ADDENDUM NO. 2

BID NO. 2838

**CLOVIS EAST HIGH SCHOOL CTE FARM AND FOOD PRODUCT FACILITY
CLOVIS UNIFIED SCHOOL DISTRICT
CLOVIS, CALIFORNIA**

G.A. PROJECT NO. 1739

12 DETAIL
SCALE: 1-1/2"=1'-0"

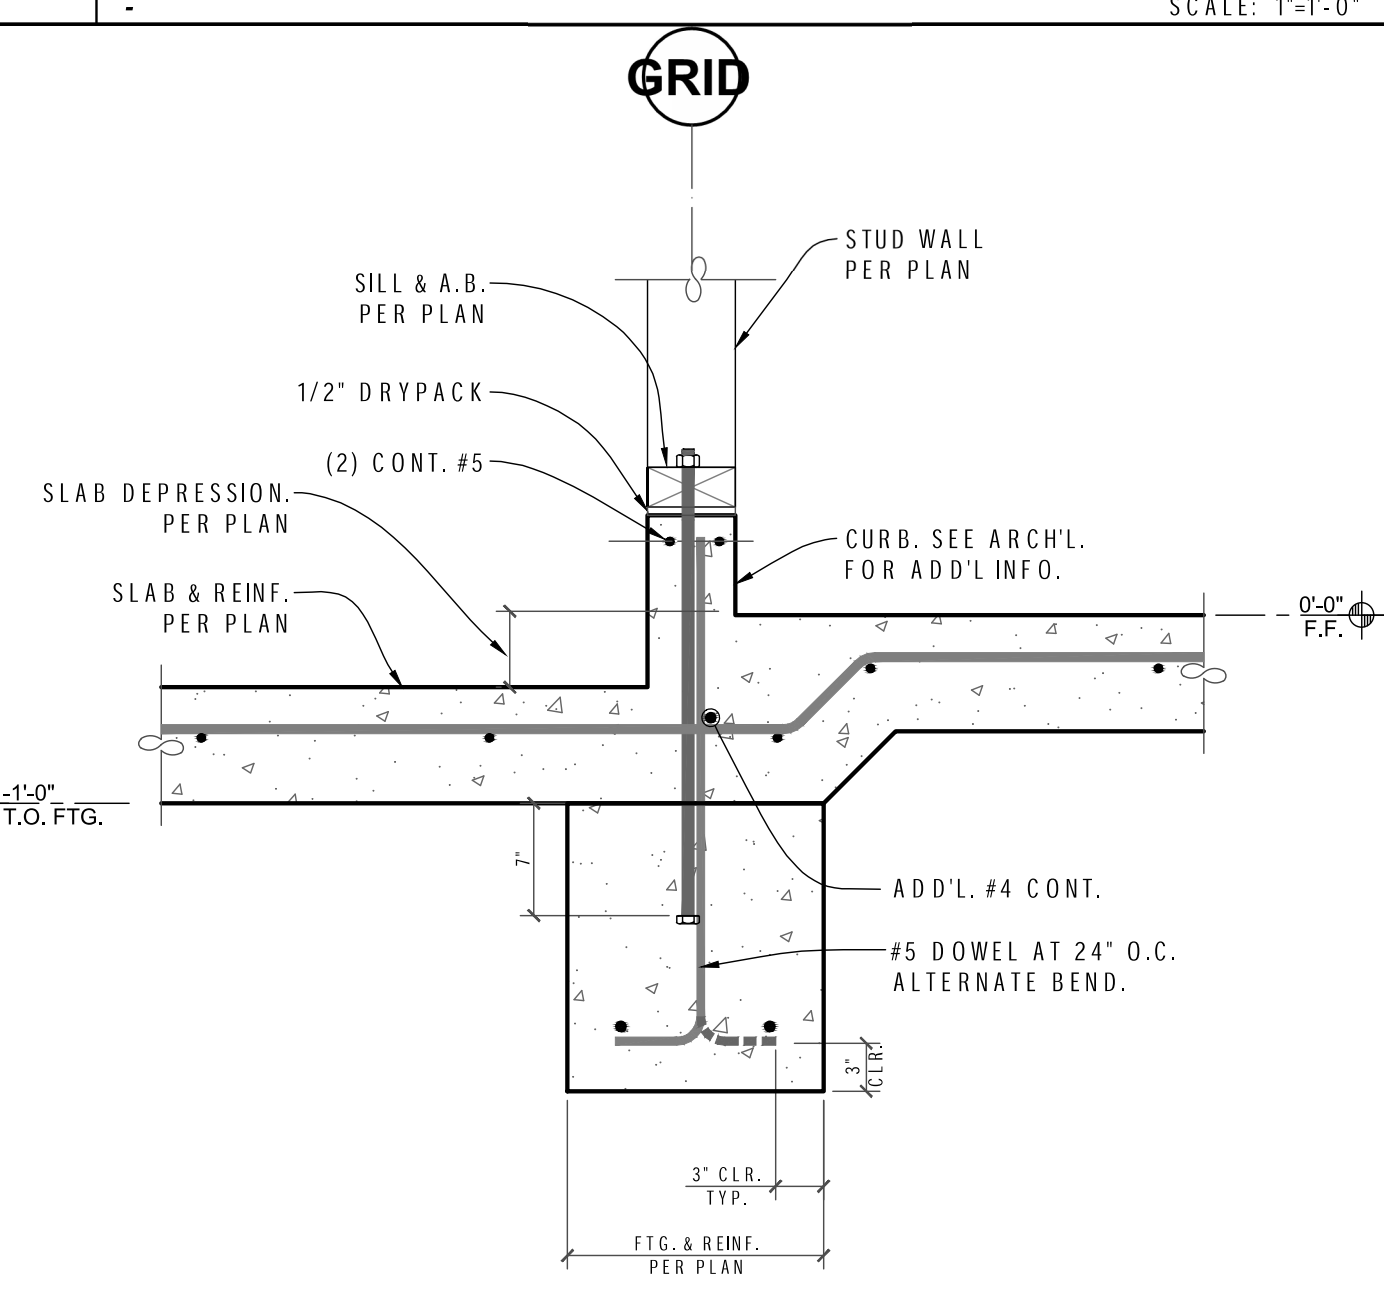
S6.2:

- 1.) Clarified weld call outs on detail 1.
- 2.) Revised and clarified soffit extent and WF beam detail Information on detail 3 and detail 4.
- 3.) Provided detail call out on detail 5.
- 4.) Revised detail 7.
- 5.) Clarified nailing on detail 8.

E1.01

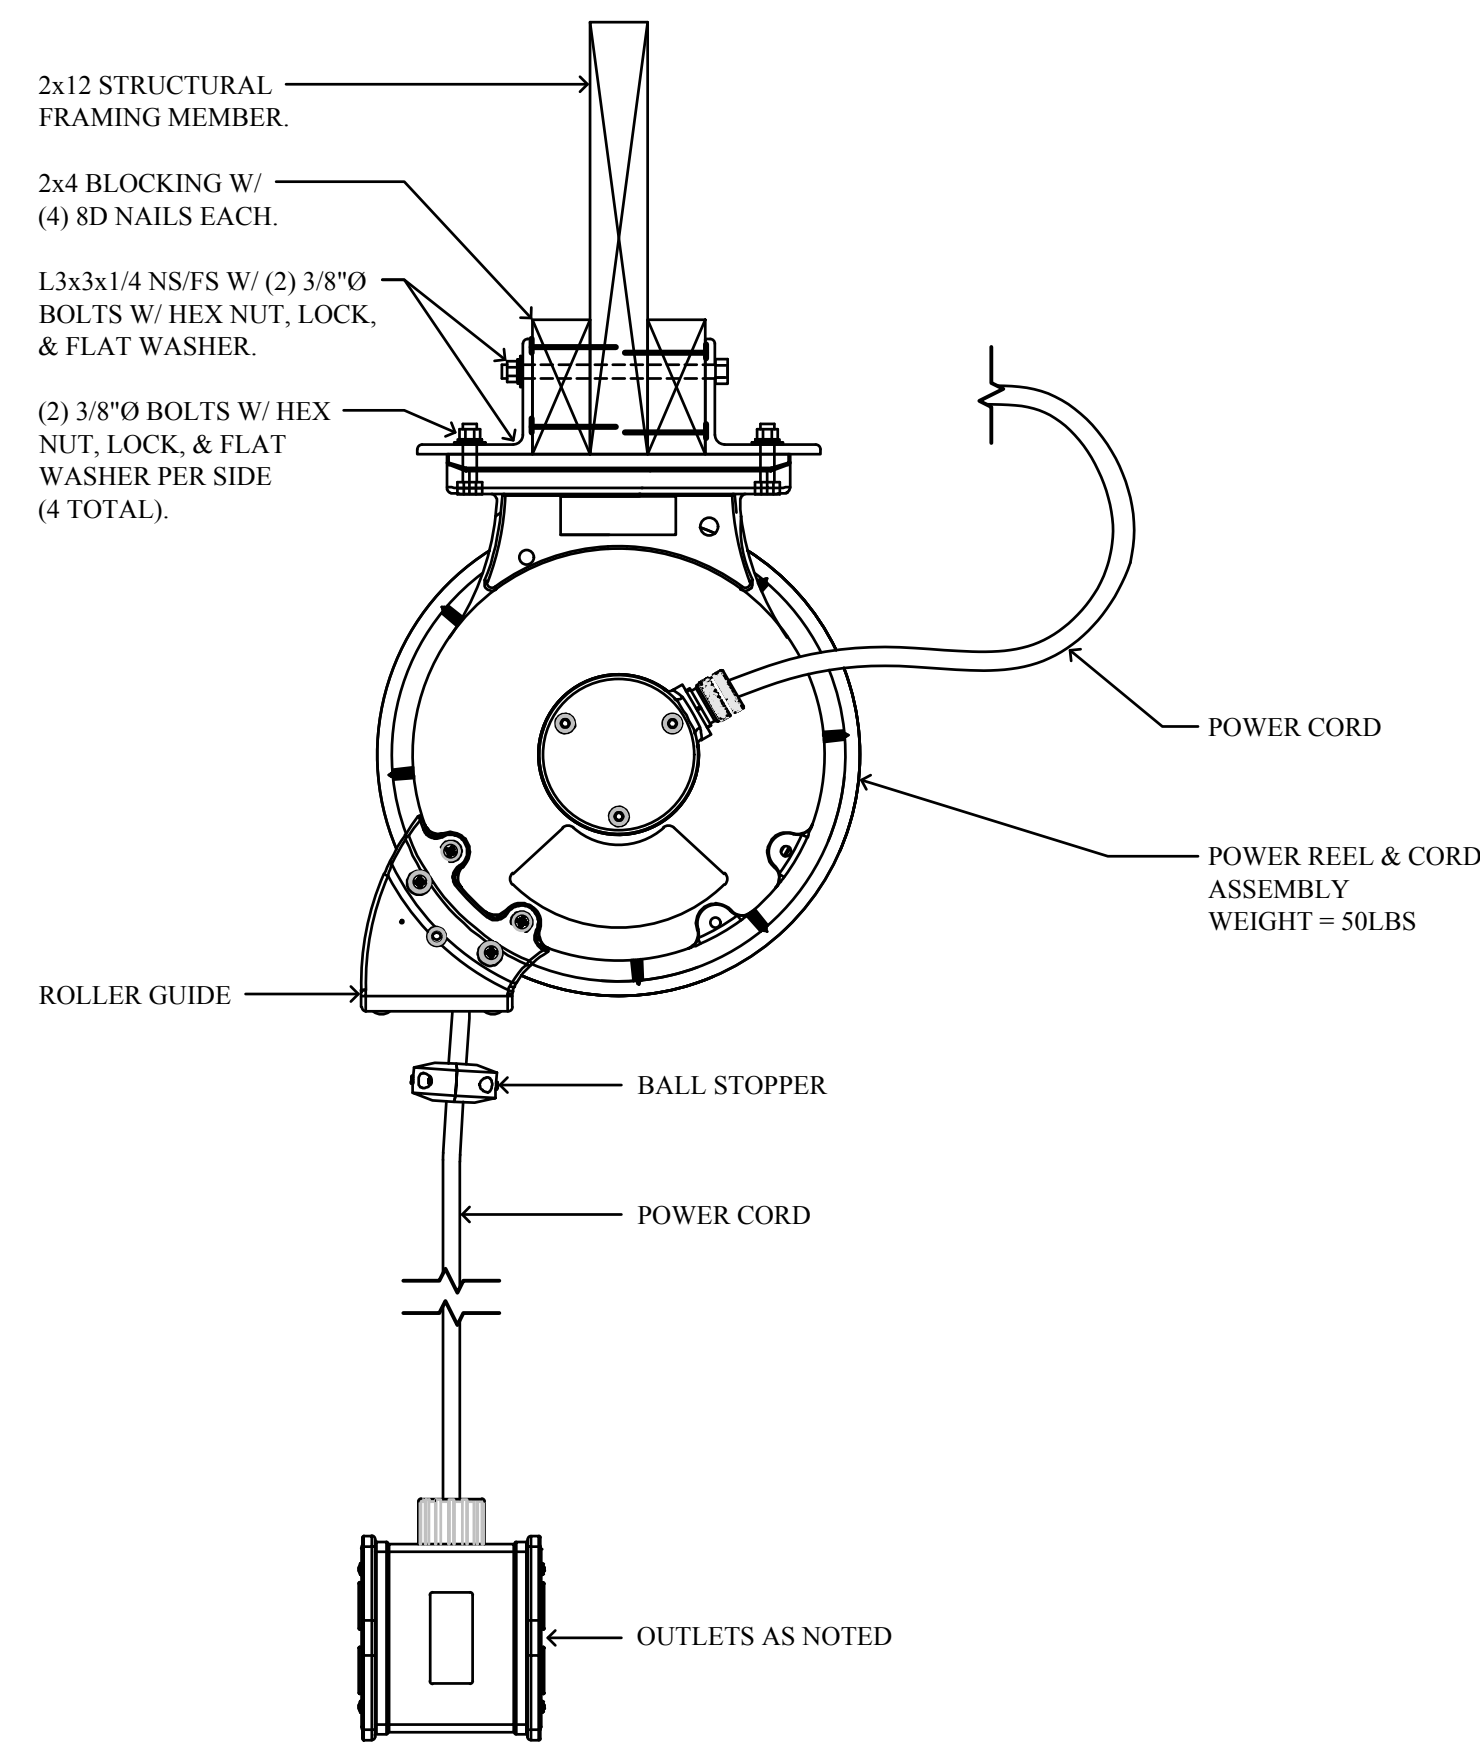
Refer to sheet E1.01

1. Revised symbol description and note for wall clock.

E5.02

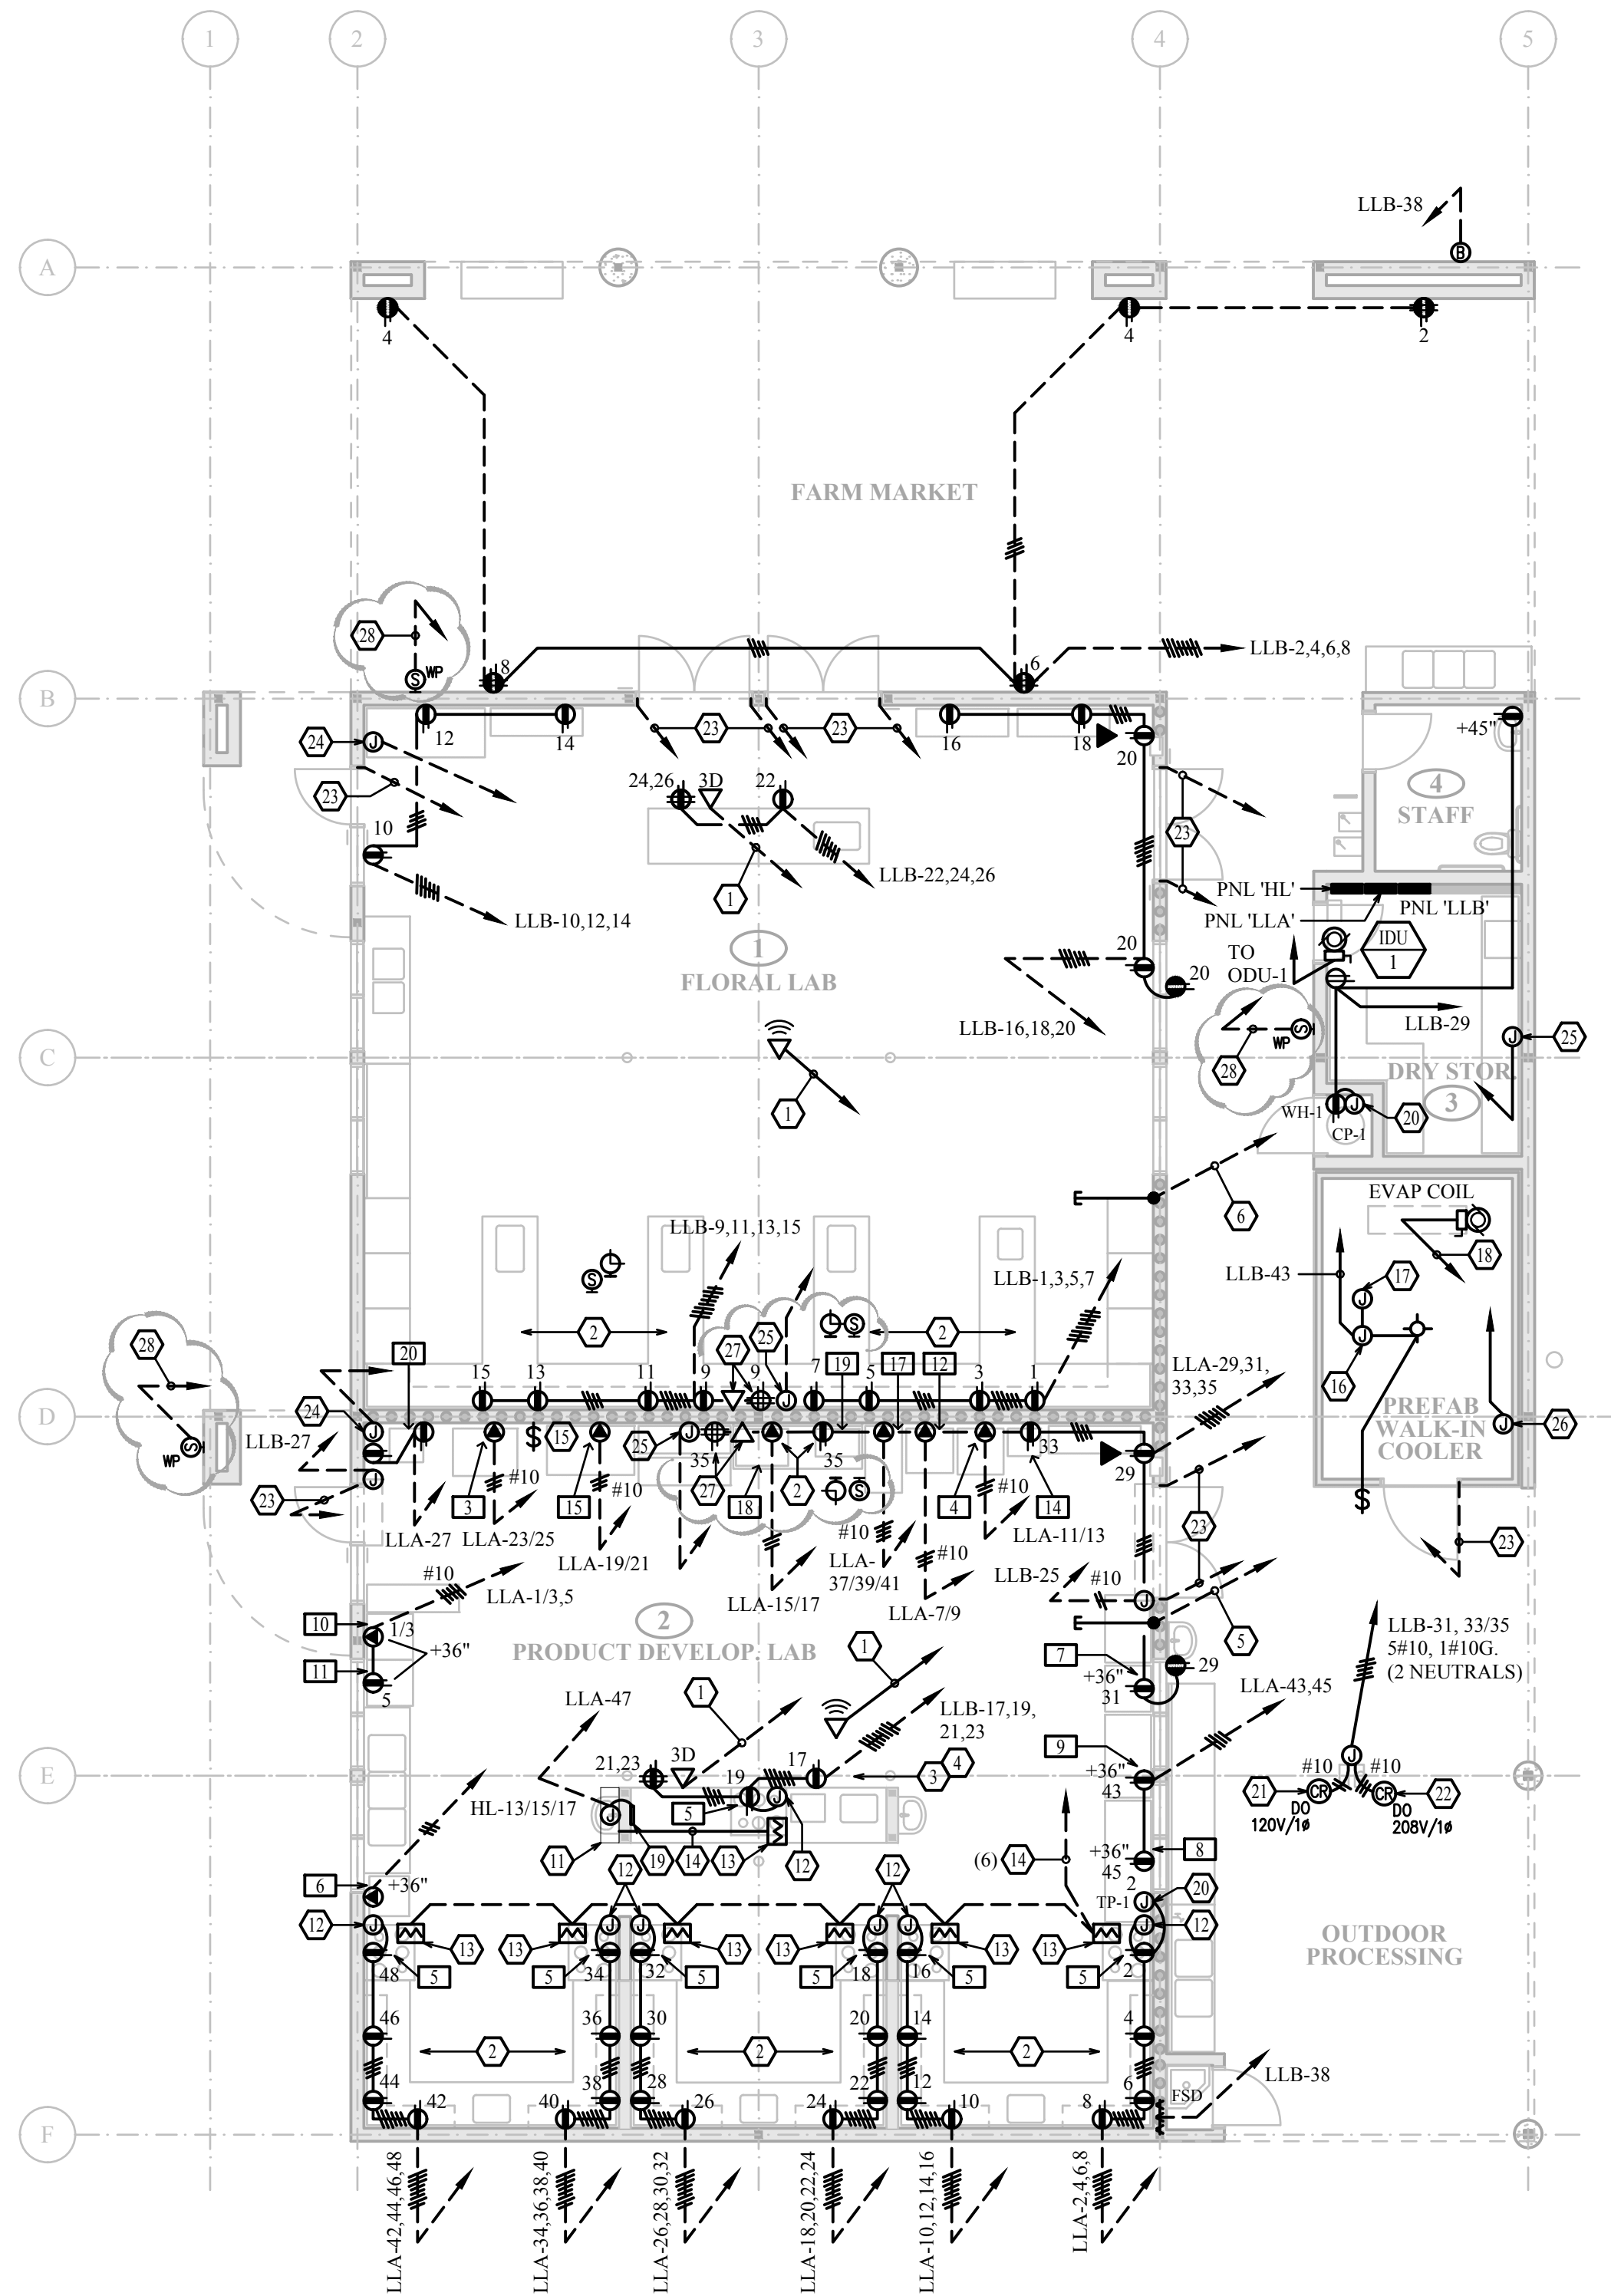
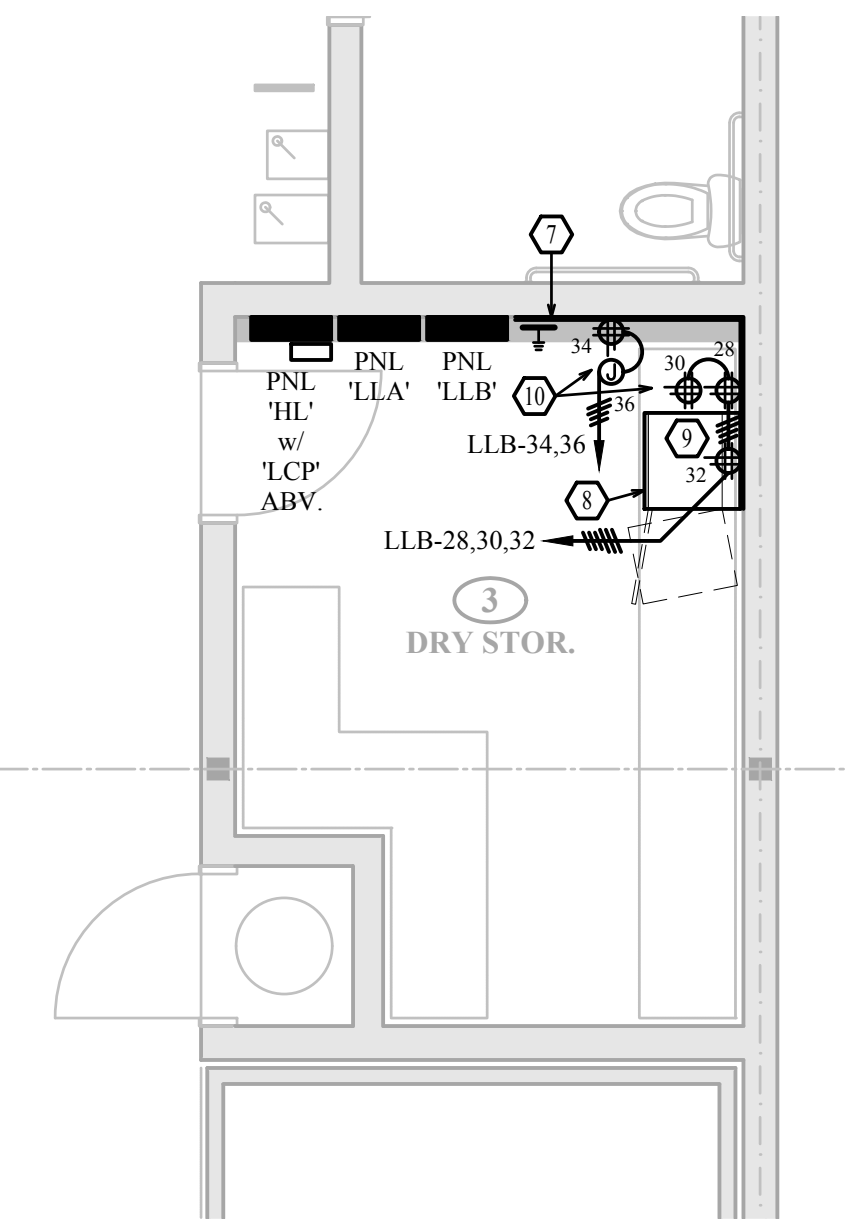
Refer to sheet E5.02

1. Added power and data outlets for wall mounted TV monitor at Floral Lab and Product Develop. Lab.
2. Added wall clock and PA speaker at Floral Lab and Product Develop. Lab.
3. Added exterior PA speakers.
4. Revised Keynote 7.
5. Added Keynotes 27 and 28.
